Access Compliance Report

Public Rights-of-Way

(Curb Ramps)

Intersection ID: 22578	Main Street: MAGNOLIA_BRIDGE_RD	Cross Street: QUAIL_HOLLOW_RD	Location: SW
ADA ID: E1CB91EFEF22	Ramp Type: PerpDiag	Initial Pass/Fail: Fail	Overall Compliance: No
		Severity Score: 47.5

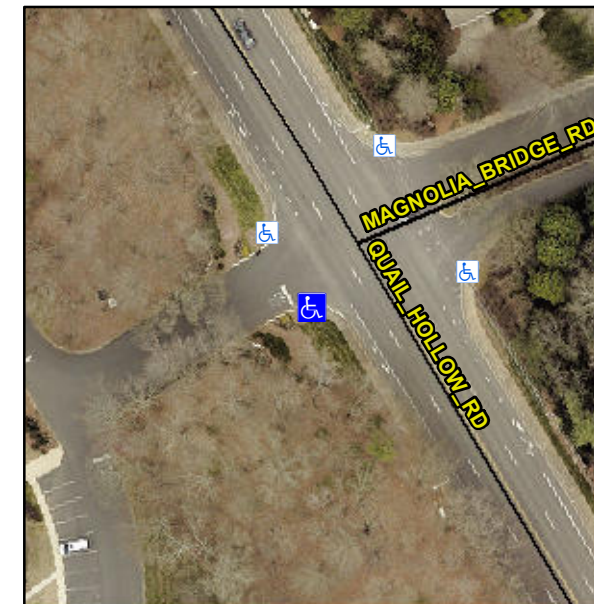
Not Found, R304.5.1, R304.2.2

Compliance	Description	Data	Compliance	Description	Data
N/A	Ramp Length (in)	61.0	No	Ramp Slope (%)	8.8
No	Ramp Width (in)	31.0	Yes	Ramp XSlope (%)	1.4
N/A	Flare Type LT	N/A	N/A	Flare Type RT	N/A
N/A	Flare Slope LT (%)	N/A	N/A	Flare Slope RT (%)	N/A
N/A	Flare Traversable LT?	N/A	N/A	Flare Traversable RT?	N/A
N/A	Landing Length (in)	N/A	N/A	DWS Provided?	N/A
N/A	Landing Width (in)	N/A	N/A	DWS Contrast?	N/A
N/A	Landing Slope (%)	N/A	N/A	DWS Length (in)	N/A
N/A	Landing X Slope (%)	N/A	N/A	DWS Full Width?	N/A
N/A	Landing Curb? (Y/N)	N/A	N/A	DWS Offset (in)	N/A
N/A	Shared Landing?	N/A			
N/A	Gutter Ponding?	N/A	N/A	Gutter Slope (%)	N/A
N/A	Gutter Lip Ht (in)	N/A	N/A	Gutter X Slope (%)	N/A
N/A	Painted X Walk1?	No	N/A	Painted X Walk2?	No
	X Walk 1 Direction	To E		X Walk 2 Direction	To NW
N/A	X Walk 1 Width (in)	N/A	N/A	X Walk 2 Width (in)	N/A
	X Walk 1 Slope (%)	0.7		X Walk 2 Slope (%)	3.0
	X Walk 1 X Slope (%)	2.1		X Walk 2 X Slope (%)	0.8

Remove & Replace Curb Ramp With Two New Directional Ramps or Equivalent.
